Rezoning Transportation Analysis

Petition Number: 2020-112

Date	Description
09-11-20	First Review

FIGURE 1 & 2: Recommended Street cross-sections

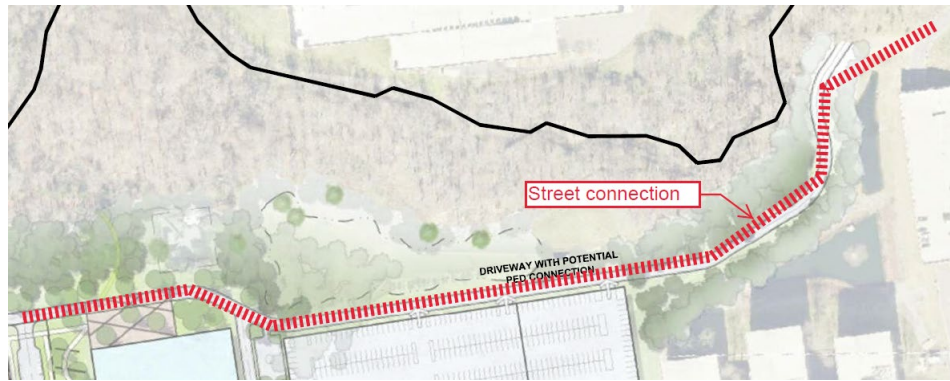
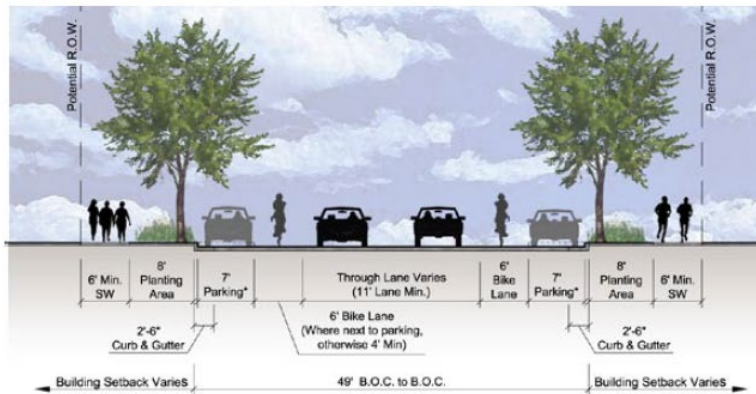
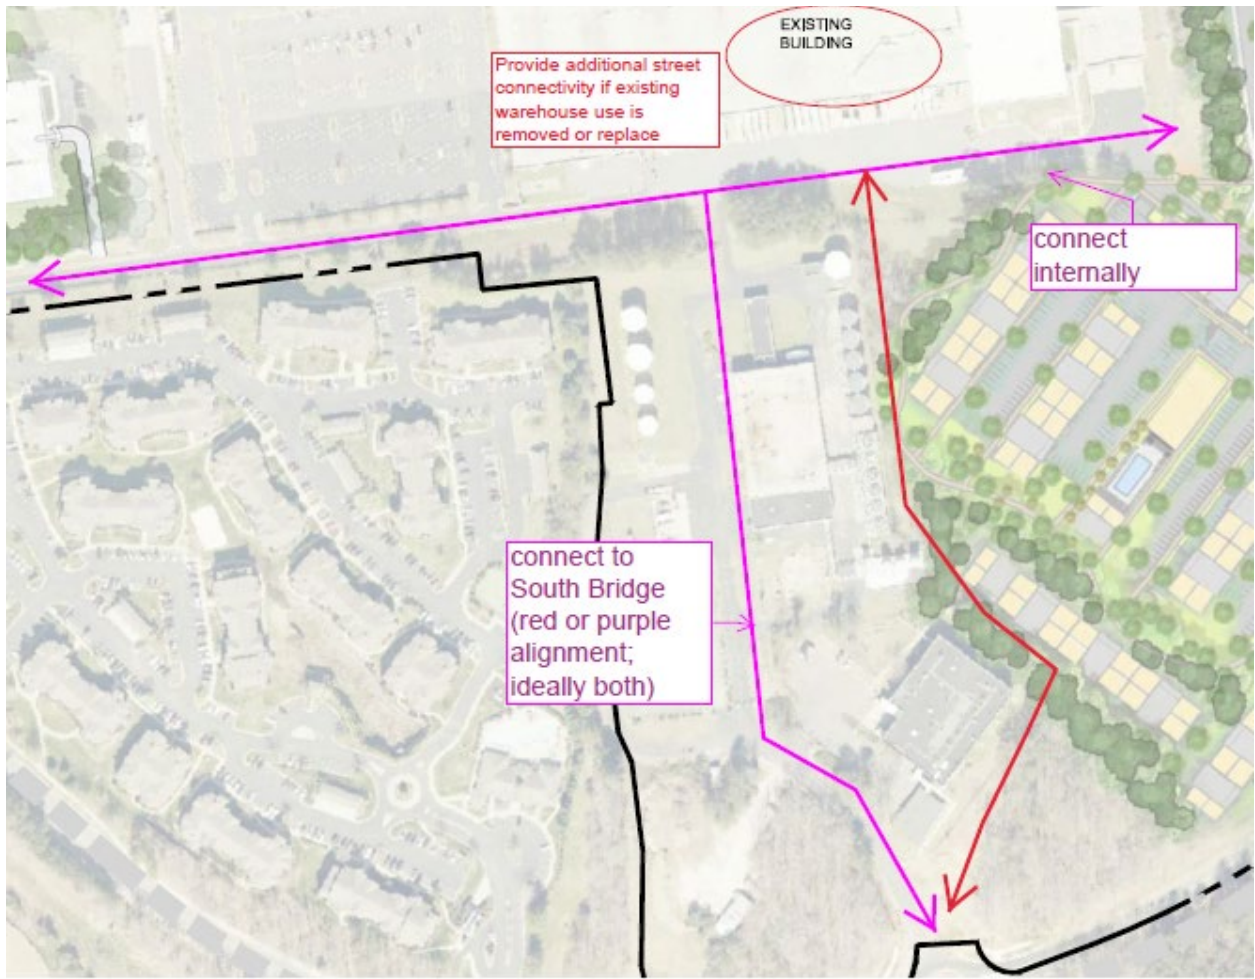
- The site plan and conditional note(s) need to establish a street connection, as shown below, according to the proposed avenue cross section that is recommended within the University Research Park Area Plan. Refer to pages 38 and 41.

- 49-foot Back of Curb to Back of Curb
Min. 77-foot right-of-way
- 6-foot Sidewalk: Improved pedestrian realm, compliant with ADA (Americans with Disabilities Act)
- Bike Lane: 4-foot Min, 6-foot where on street parking is present - safer bicyclists realm, improved truck turning radius, additional buffer for pedestrians
- Planting area: Buffer for pedestrians; beautification
- On street parking: additional buffer for pedestrians, shared parking, active streetscape
